**STAFF REPORT**  
**DEVELOPMENT REVIEW COMMISSION - VARIANCE REQUEST**  
**PUBLIC HEARING**

CASE NO.: 22-54000068 PLAT SHEET: E-38

REQUEST: Approval of a variance to setbacks for the construction of a freestanding sign.

ADDRESS: 7141 4<sup>th</sup> Street North

PYL-W-1

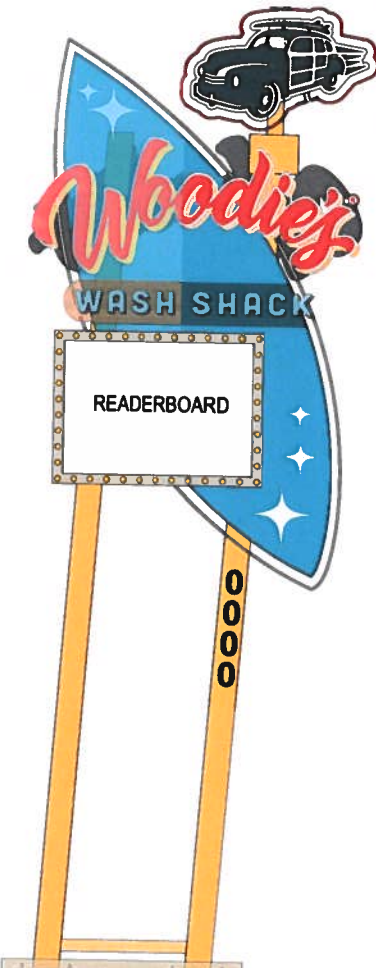
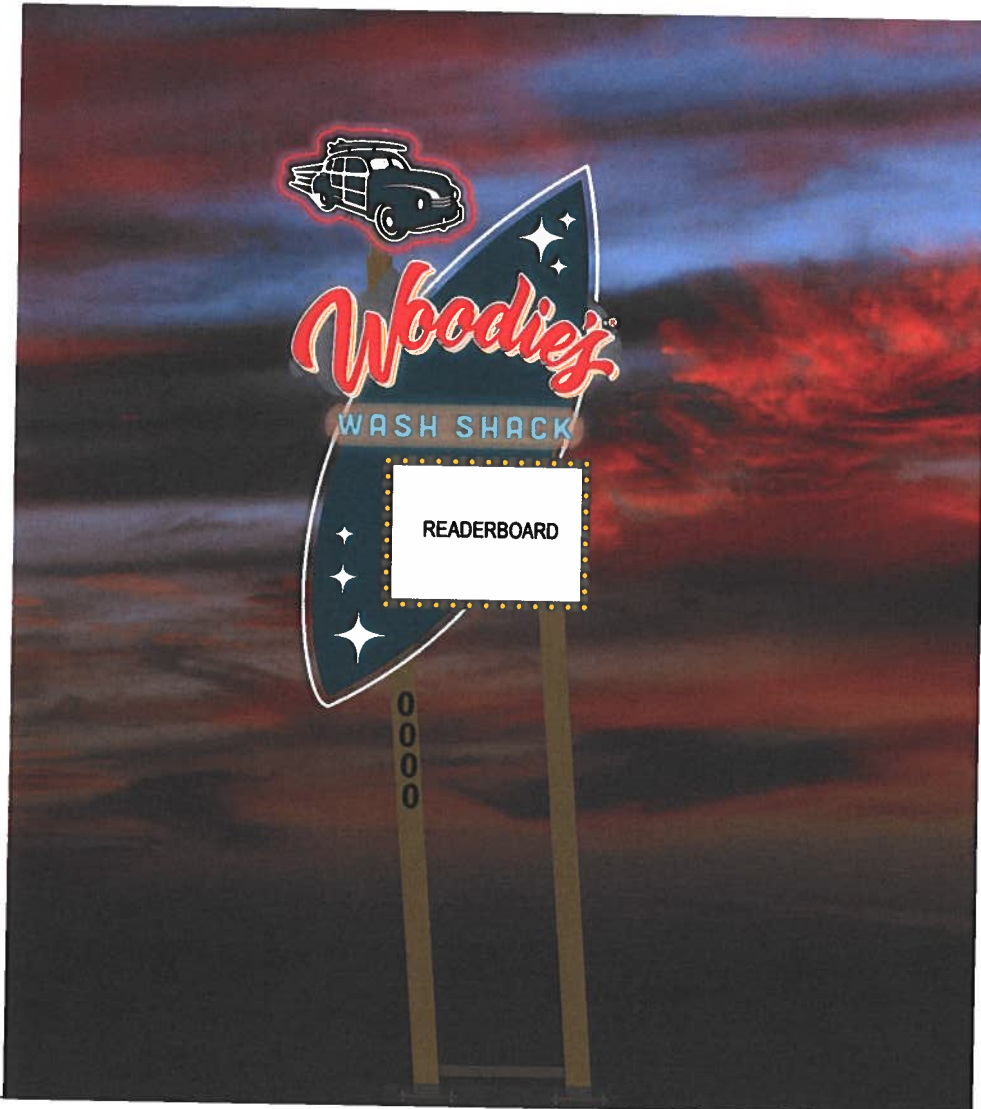
The proposed project does not promote the establish development pattern of the street. While many signs on the 4<sup>th</sup> Street commercial corridor are similar in size to the sign proposed in this application, these signs are either nonconforming due to their location or are located further from the street to meet Code setback requirements. The street the subject property is situated on is a State-owned and FDOT-maintained minor arterial street.

The variance request is self-imposed by the Applicant. The original car wash development was approved via Special Exception with a 10-foot tall monument sign receiving permit approval in August 2020. A similar sign could replace the existing sign in the same size, height, and location as the existing sign with no variances required.

The literal enforcement of the Code regulations would not result in unnecessary hardship. The existing conforming monument sign can be repurposed, reconstructed, or refaced for use by the new car wash business.

The granting of the requested variance will not be in harmony with the general purpose and intent of the Sign Code. One of the primary purposes of the Sign Code is to establish the minimum standards necessary to reduce the visual distraction and safety hazards created by sign proliferation along the public rights-of-way. The Sign Code regulations attempt to reduce the visual distraction and potential safety hazards posed by the oversaturation of signage facing thoroughfares. The subject property being situated on a major roadway makes these considerations even more apparent.

The granting of this variance could be detrimental to the public welfare. The oversaturation of street facing signage in the immediate viewshed of vehicular traffic could be a safety concern.

The reasons set forth in this application do not justify granting of a variance. The existing sign could be reconstructed to accommodate the new business, other types of signage is available to the business, and the request is not in harmony with the purpose and intent of the Sign Code.

When our city worked with the neighborhoods and others in the community to update our sign code in 2007 it was with the purpose of improving the appearance of our streetscape by reducing the number of oversize signs that blight and blot out views along our roadways. In the CCS-1 zoning district the subject business could by right install a sign by height at the following setbacks below. The applicant is asking for a variance to install a maximum height sign for CCS-1 (20 feet) at a non-conforming setback of 3 feet. They could instead just install a 10-foot sign at the 3-foot setback – as was done by an unrelated business located just across the street.

One purpose of our sign code is to reduce visual clutter while ensuring that business owners have the ability to communicate the presence of their business to motorists. A 20-foot sign this close to the roadway does not do a better job at this than a 10-foot sign at the same location. All a higher sign does is contribute to clutter and detract from the visual appeal of the area. This is in conflict with the reason for and the intent and prior application of our sign code.

**STAFF RECOMMENDATION:** Based on a review of the application according to the stringent evaluation criteria contained within the City Code, the Planning and Development Services Department Staff recommends **DENIAL** of the requested variance.
